LARAMIE COUNTY PLANNING & DEVELOPMENT DEPARTMENT

MEMORANDUM

TITLE: PUBLIC HEARING for a Subdivision Permit and Plat for Fox Hill, located

Attachment 6: Agency Comments Report
Attachment 7: Existing Conditions Map

EXISTING CONDITIONS MAP for

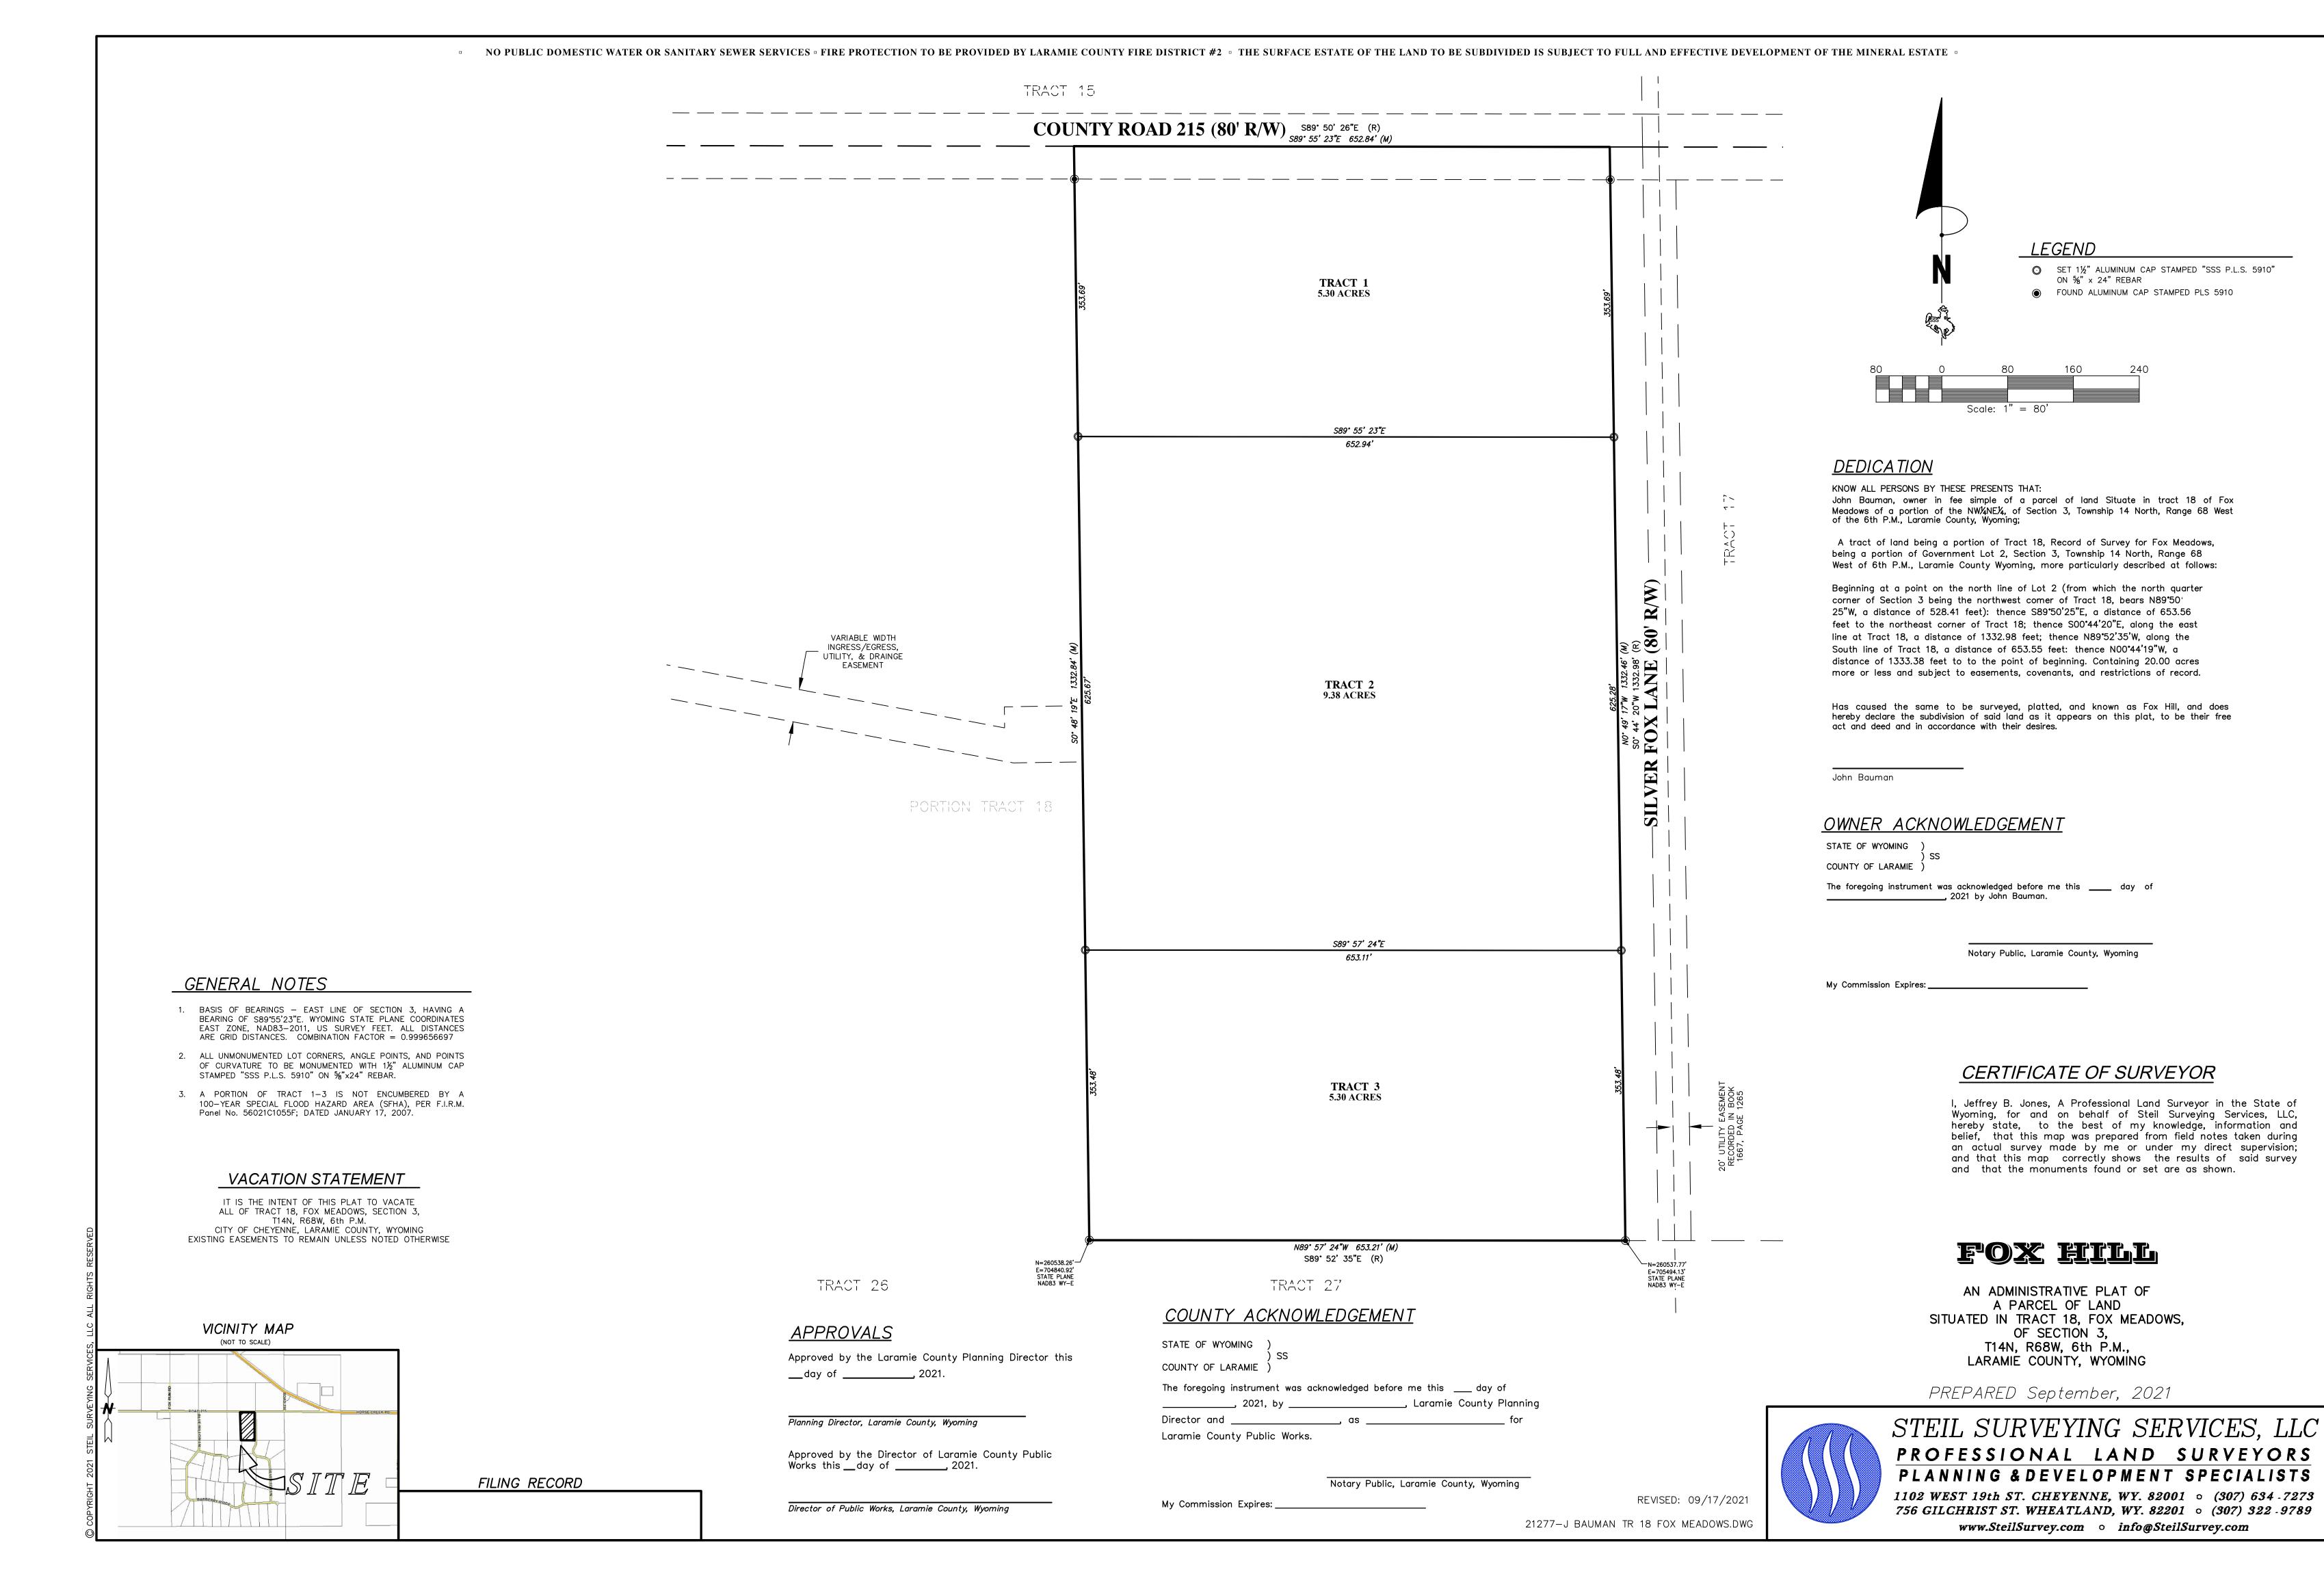
The legal description from when John Tate Bauman took title notes the legal "BEG AT A PNT ON THE NORTH LINE OF LOT 2, FROM WHICH THE NORTH 1/4 COR OF SEC 3, BEING THE NW COR OF TRACT 18, BEARS N. 89 DEG 50'26"W, 628.41'; "Which varies from the plat map noting a distance of 528.41. The plat legal also spells corner incorrectly.

Fox Meadows was a Record of Survey so the info on plat, including the Title Block, will need to be updated.

<u>County Attorney:</u> County Attorney, Joe Chenchar Comments Attached 10/01/2021 1. Be fore to remove the language "administrative" before the word plat, since this is not an administrative plat.

2. Modify vacation statement - this plat can't vacate the entirety of Tract 18 since the Fox Hill subdivision only exists on a portion of tract 18.

- 1. I concur with the request for a waiver of a detailed Drainage Study and Traffic Study, at this time since the proposed action will have a negligible impact on both.
- 2. Under the title "Fox Hill", the word "Administrative" should be removed since this is not an administrative plat.
- 3. Also, since Fox Meadows is a record of survey and not a plat that legally created the Tracts, etc. I do not believe it is correct to reference that in the title and in the Vacation Statement. I don't know that you can vacate a Tract that has not been legally established by platting.
- 4. On the Legend (and any future plats that are to be submitted), please include the various line types and their designation.

- 5. The ROW line type used for County Road 215 is different than the one used for the eastern ROW line for Silver Fox Lane. Just for clarification, is the eastern most dashed line is the eastern ROW line for Silver Fox Lane because that would be 80' from the platted boundary for Tracts 1 -- 3 and not the dashed line 20' to the west which is the same line type used for the CR 215 ROW but it is not 80' from the property line (it is only 60' from the property line and the label for Silver Fox Lane indicates an 80' R/W). This is another reason why having the line types included in the Legend is important. However, when I look at the Record of Survey for Fox Meadows, it shows the 20' Utility Easement is east of the 80' ROW, so that would indicate that the ROW lines shown on the plat would only allow for a 60' ROW instead of 80'. Clarification for all the lines and distances for Silver Fox Lane is needed.

- 6. General Note 3 may be easier understood if it was modified to read "No portion of Tracts 1-3 are encumbered by..." The way it reads now is confusing.

- 7. According to the Laramie County GIS, the current owner is listed as John Tate Bauman and should that be reflected on the plat instead of just John Bauman?

- 1. There is no survey tie by bearing/azimuth and distance to the nearest public land survey system shown on the drawing of this plat.
- 2. The road names and/or numbers are very small and difficult to read.
- 3. The Vicinity Map would be easier to read and it would be more useful to the 'lay public' if one were to add some information such as, at a minimum, the Section, Township and Range data with enough detail to indicate the location of the subdivision within the Section.
- 4. Is the VARIABLE WIDTH INGRESS/EGRESS UTILITY, & DRAINAGE EASEMENT tying into the west boundary of TRACT 2 recorded on another plat or should it be referenced to Register's book and page number?

Fox Meadows is just a survey, so the title block needs to reflect this.

John took title with his full middle name (Tate). Please add middle name to all places where his name appears (dedication, signature area, and notary block)

- 1. Remove "Administrative" from the title of this plat.
- 2. Owner's full name as recorded on the warranty deed is needed John Tate Bauman.
- 3. Change the signature blocks to be signed by the Chairman of the Planning Commission and the Chairman of the Board.
- 4. Vacation statement not necessary as this is based on a record of survey, not a previously platted area.
- 5. Describe the type of sewage disposal and the type of water supply (ex: private well).
- 6. Is the utility/drainage easement on the western portion of the plat proposed or

recorded? If recorded, add book and page number.

- 7. Change the wording on note 3 to make more clear. "No portion of tracts 1-3 are encumbered by..."
- 8. Add a note describing wildfire hazard level as this property lies within a CWPP area.

1. All remaining agency comments regarding proposed and existing easements and clerical errors to the plat shall be corrected and addressed prior to recordation.
